PLANNING DEPARTMENT – Development Review Services

**RE: Sevilla @ Andalucia - (File: F11D015C)**  
**Drainage Management Plan, Engineer's Stamp Date 1-19-2015**  
**Grading and Drainage Plans, Engineer's Stamp Date 1-19-2015**

Re: Response to Comments  
Drainage Master Plan for Sevilla @ Andalucia

# DRAINAGE MASTER PLAN FOR SEVILLA @ ANDALUCIA

**EXHIBIT 3**  
**DEVELOPED BASINS MAP**

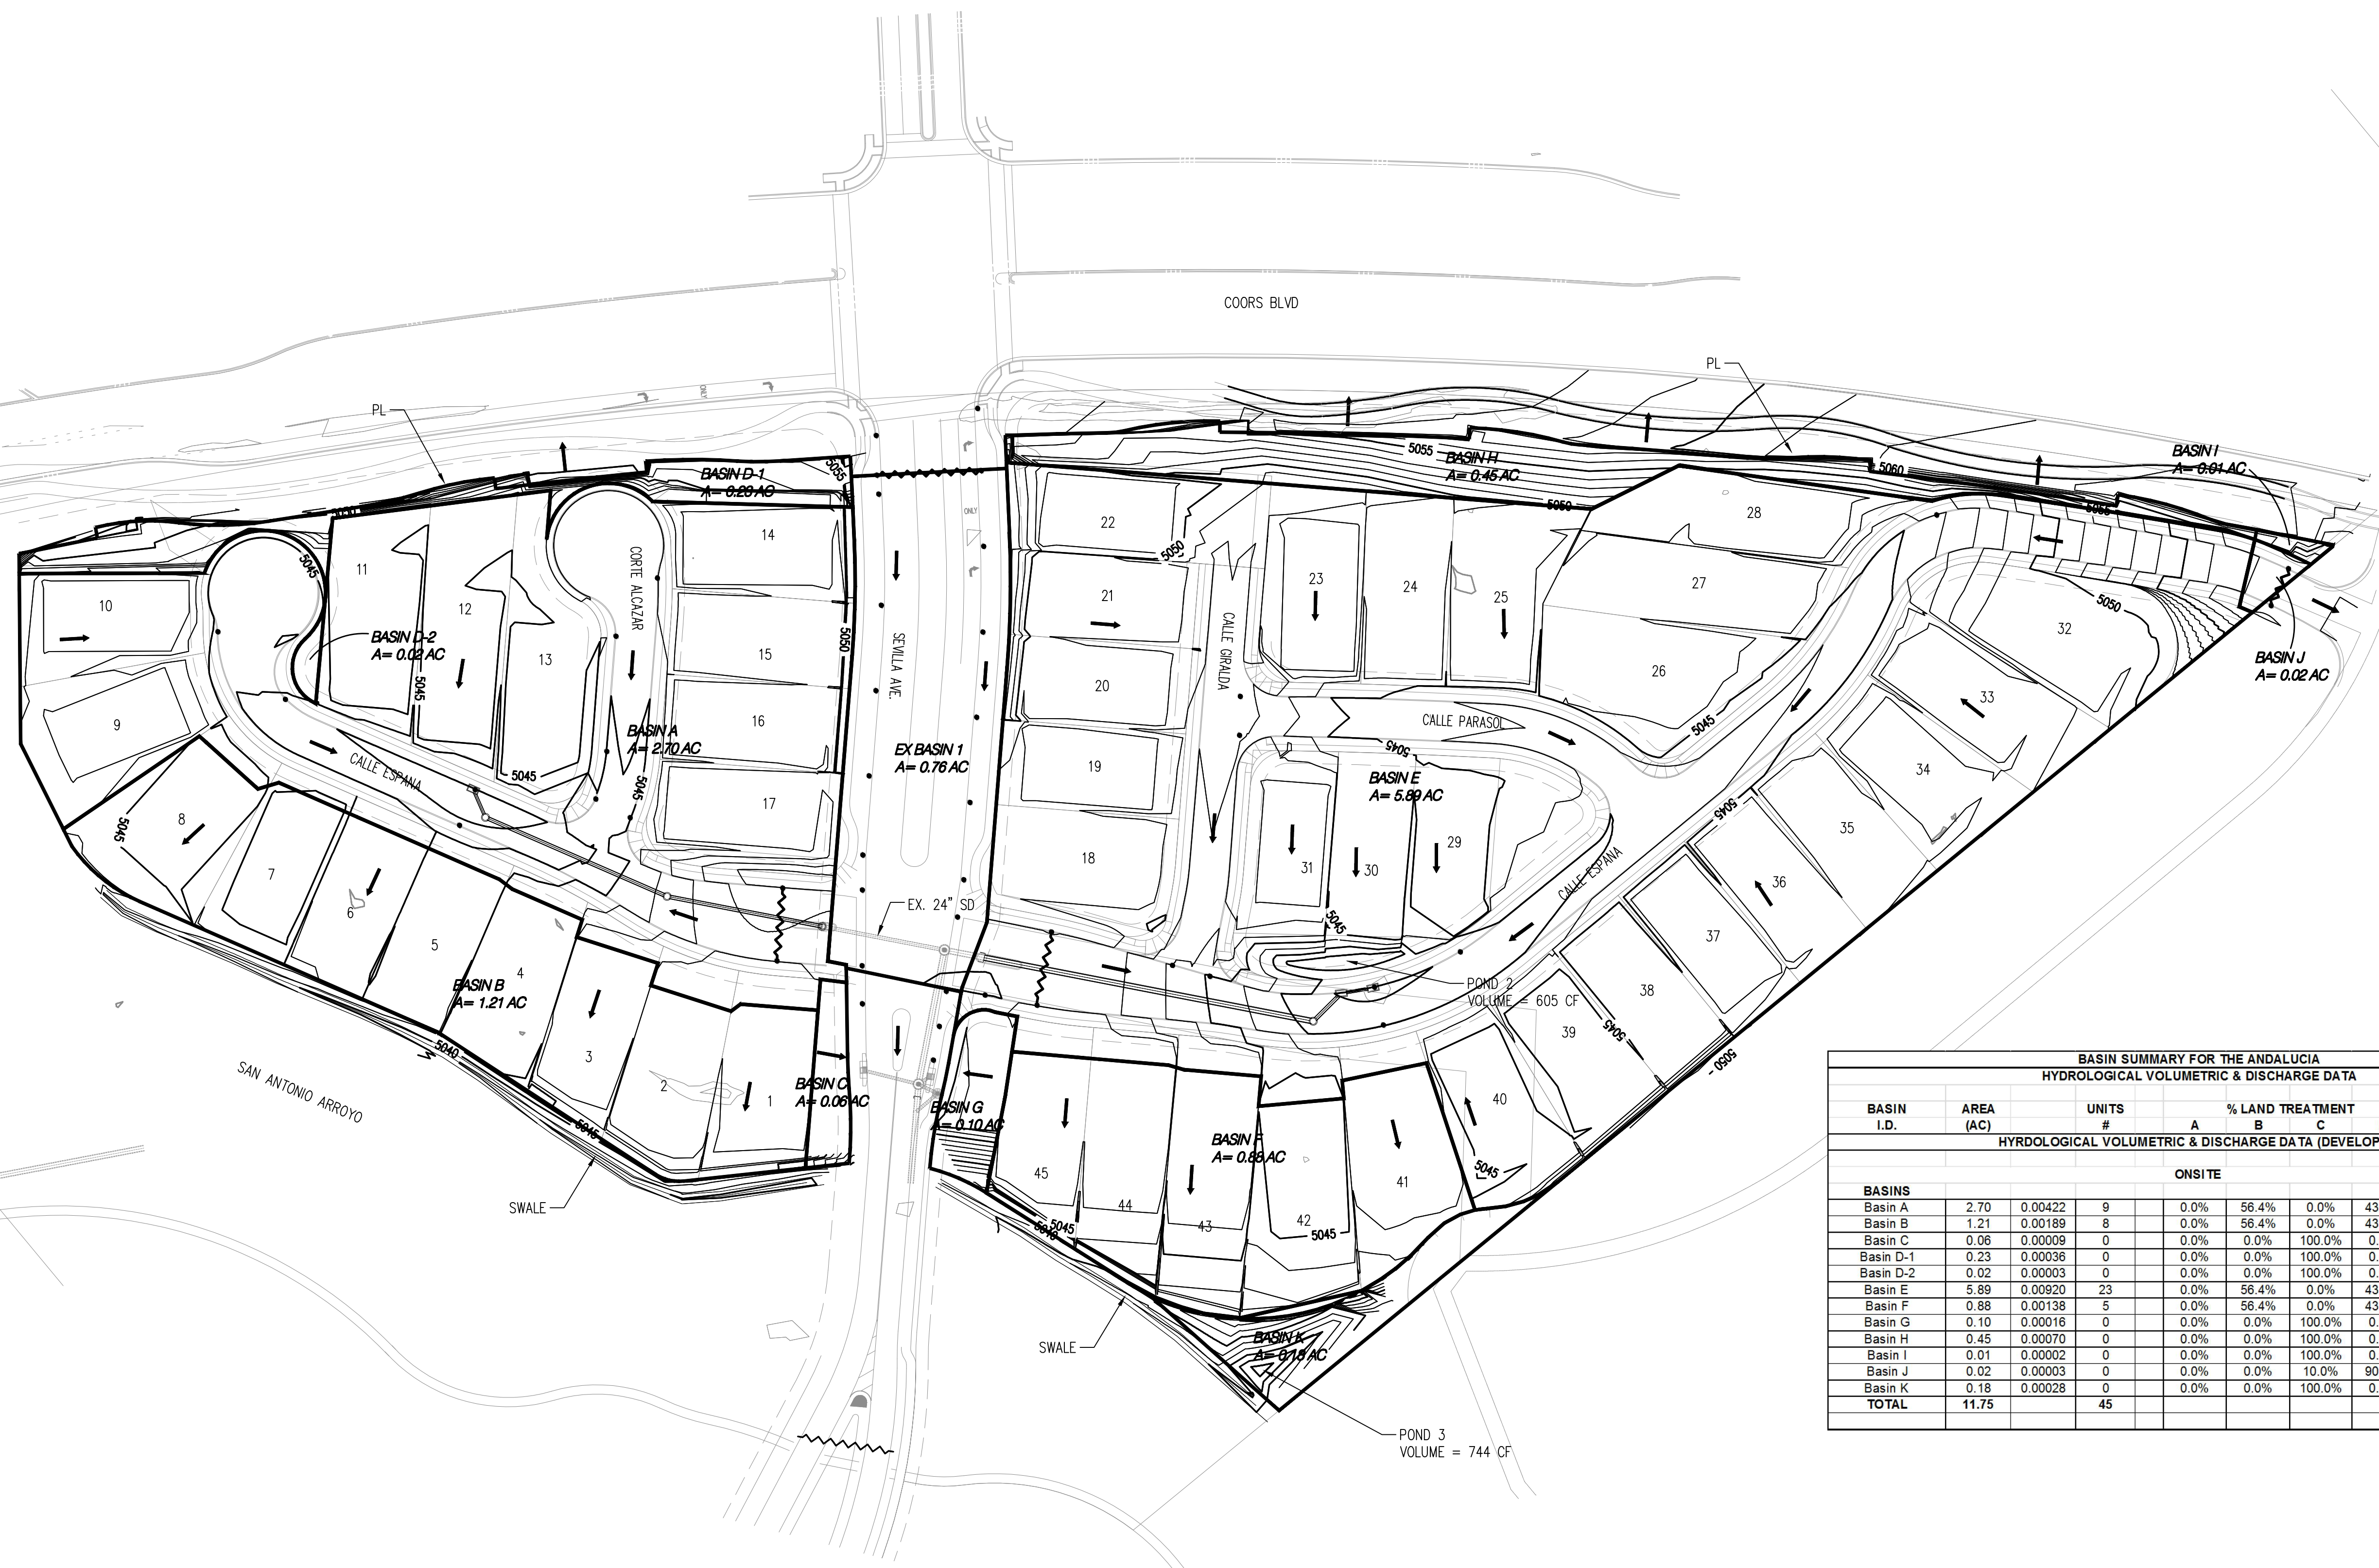
1. Show the Table in Appendix A on the Developed Basin Map
  - **Done**
2. There is a typo on page 1 of report stating site is 38 Acres.
  - **Sheet 1 has been revised.**

- **Area west of the wall in Coors Blvd drains towards Coors Blvd. Basin Map and Grading Plan have been updated to show this. ROW has been labeled on Grading Plan.**
